Re: **REQUESTED**
Changes to CMI Work Plan
Former Ciba-Geigy Facility
Lot 1102, 180 Mill Street
Cranston, Rhode Island

Requested Change No. 1: Alter clean soil cover contouring and vegetation plan

Requested Change No. 2: Modify clean soil cover design to support stormwater retention areas

RC-7

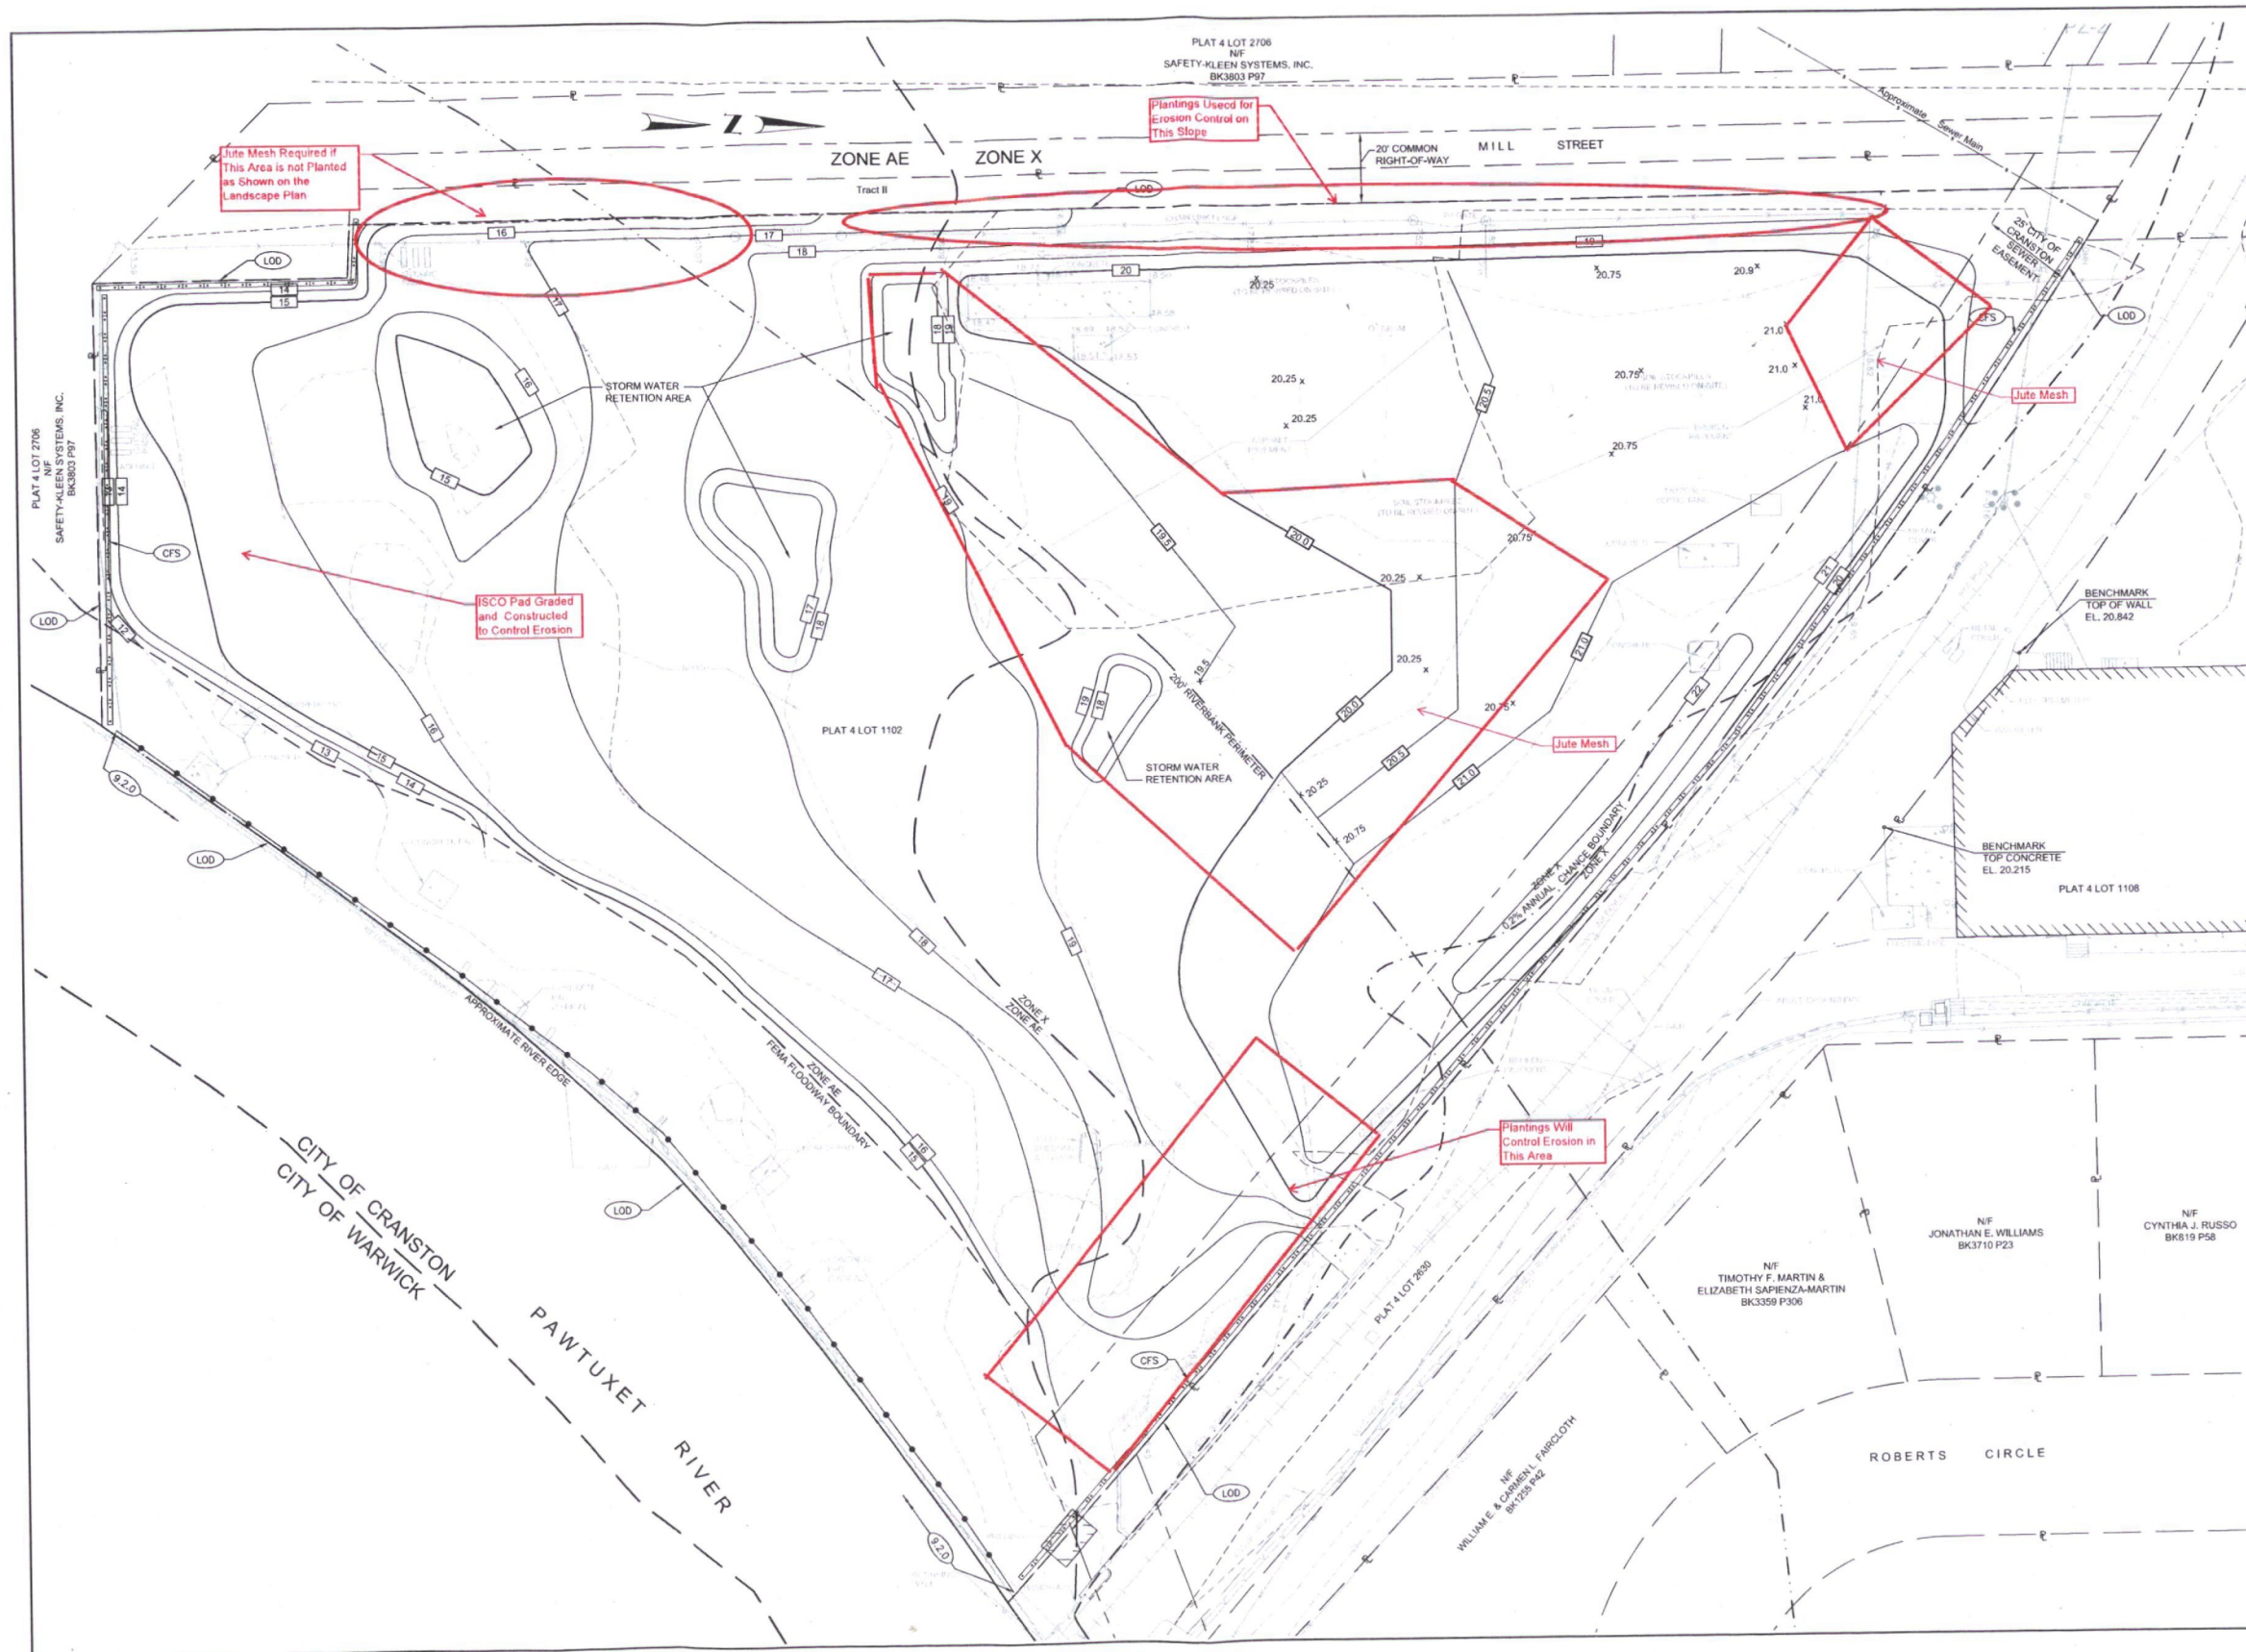
BASF proposes to modify the soil cover contouring and vegetation plan to support the potential future use of a portion of the property as a parking lot, specifically that portion that is beyond the 200-foot setback from the river. This potential future use is supported by the contouring and vegetation plan provided in drawings RC-7 and RL-1 through 4. The plan includes the following changes

- **Vegetation:** The area beyond the 200' river setback will be maintained as an open field and planted with a wildflower mix, instead of the originally conceived upland habitat vegetation.
- **Contouring:** The area beyond the 200' setback will have a uniform grade, and the following alterations are proposed to accommodate surface water runoff control requirements associated with this design and potential parking area re-design (see drawing RC-7).
 - Stormwater retention basins have been moved to the periphery of the new open field.

- In the case that the open field is redesigned to support a parking area and assuming an impervious surface, stormwater flows from this area will be directed to the south toward several stormwater retention areas or towards lined tree wells which would be positioned in the central and peripheral portions of the property. Conceptually, stormwater runoff would follow the final grades depicted on drawing RC-7. Note that any property redevelopment beyond what is presented here will, at a minimum, be constrained by the ELUR as contemplated in the CMI WP, and to be recorded with the property deed.
